**Cameco Corporation, Beaverlodge Project**

Application for the Licence Revocation and  
Transfer of Properties to Saskatchewan  
Institutional Control Program

**Comments on Cameco's request to revoke the  
current CNSC licence and release Beaverlodge  
mine and mill site properties into Saskatchewan's  
Institutional Control Program**

**Prepared by Carroll Chubb, PhD**

**Figure 14: Ra-226 Performance Indicator at TL-4**

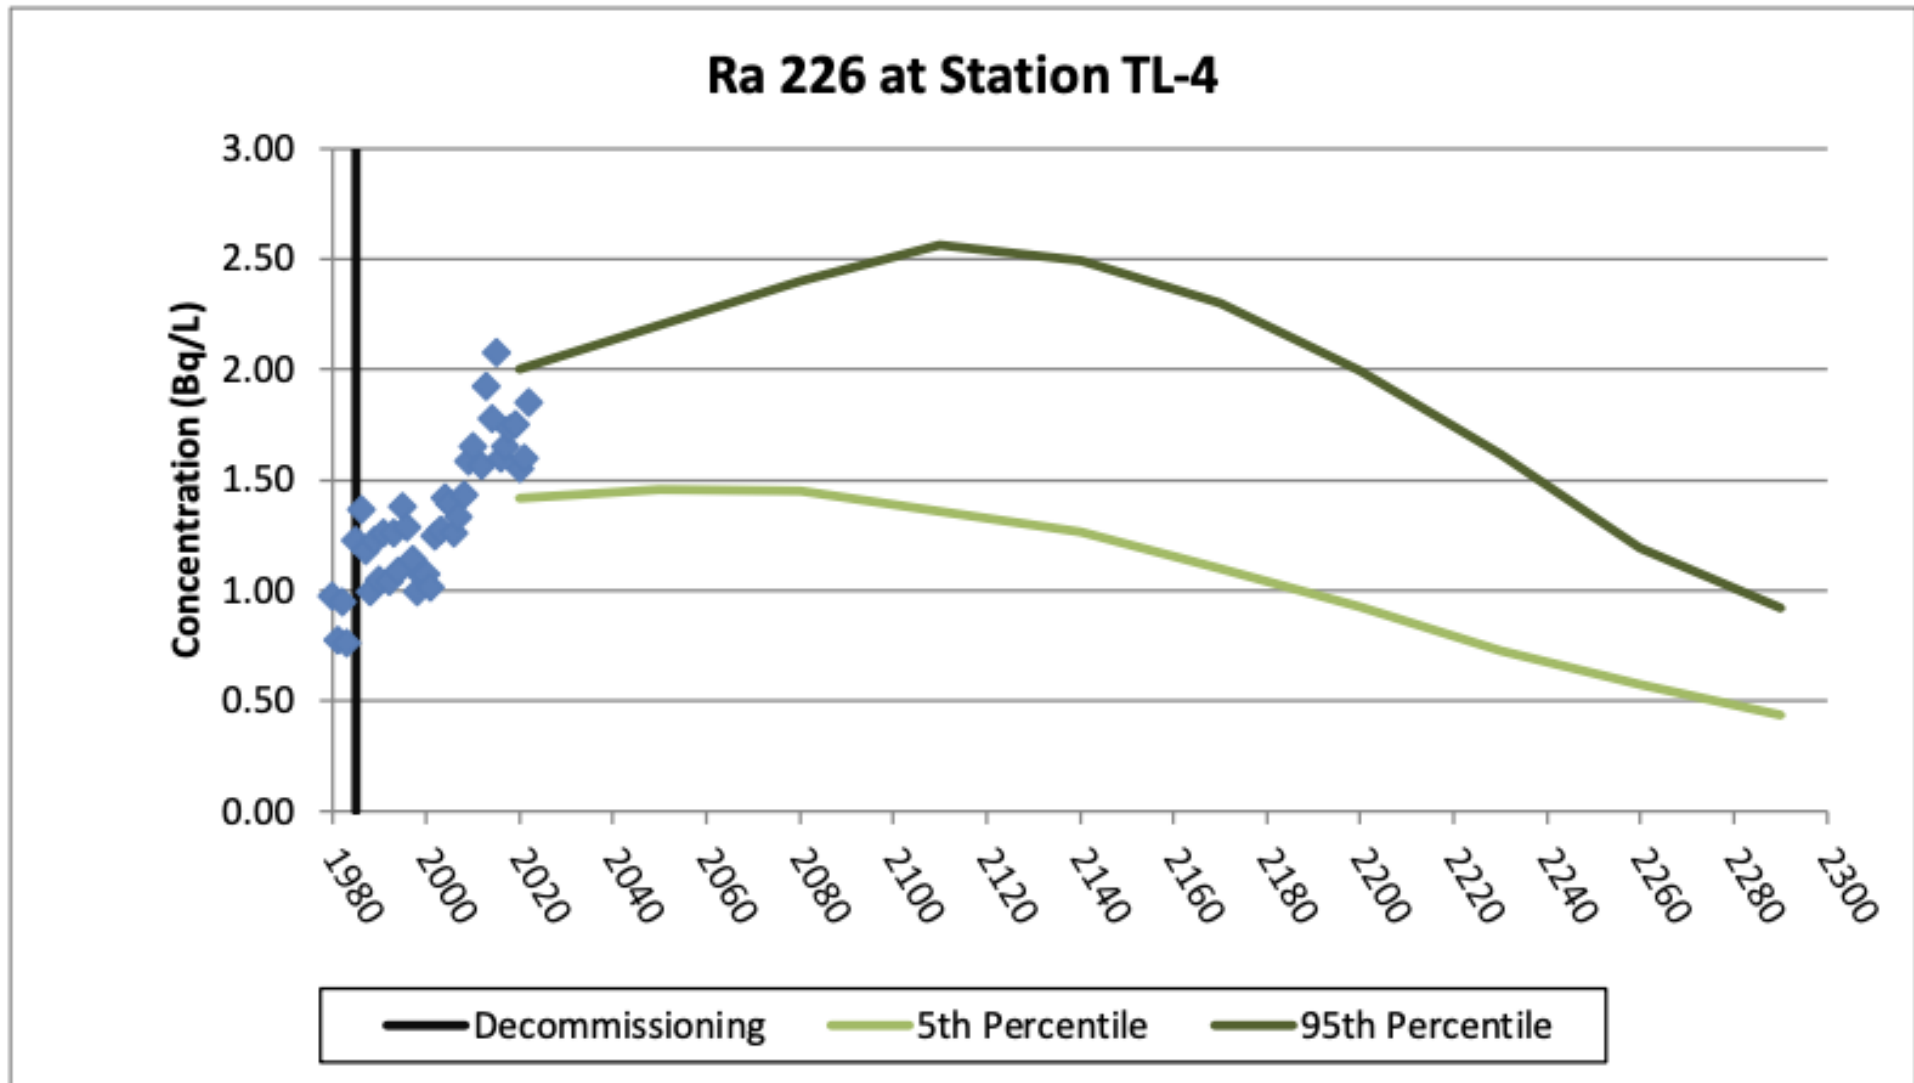
Outlet of Fookes Reservoir: Radium-226 concentrations about 14 times the concentration limit in Saskatchewan's drinking water guidelines

Outlet of Marie Reservoir: Radium-226 concentrations about 18 times that limit
